Kentbruck Green Power Hub, Victoria

Peer Review of Landscape and Visual Impact Assessment

19th February 2024

Prepared for NEOEN Australia Pty Ltd

Figure 4 – South West Victoria - Landscape Character Types and Areas (Source: Coastal Spaces Landscape Assessment Study)

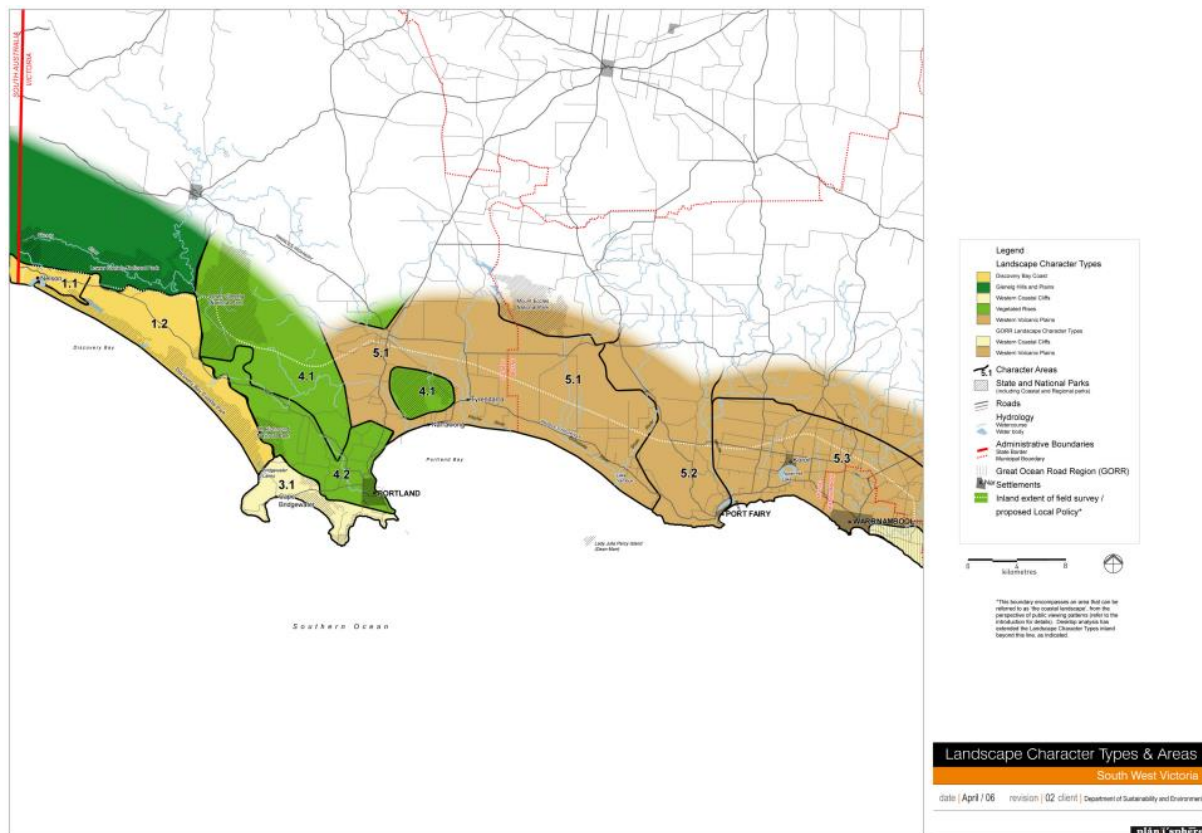
The inclusion of a relevant extract from the landscape units map from the Coastal Spaces Landscape Assessment Study may be helpful (refer to **Figure 4**)

The relevant description extracts and the landscape units map from the Coastal Spaces Landscape Assessment Study have been included.
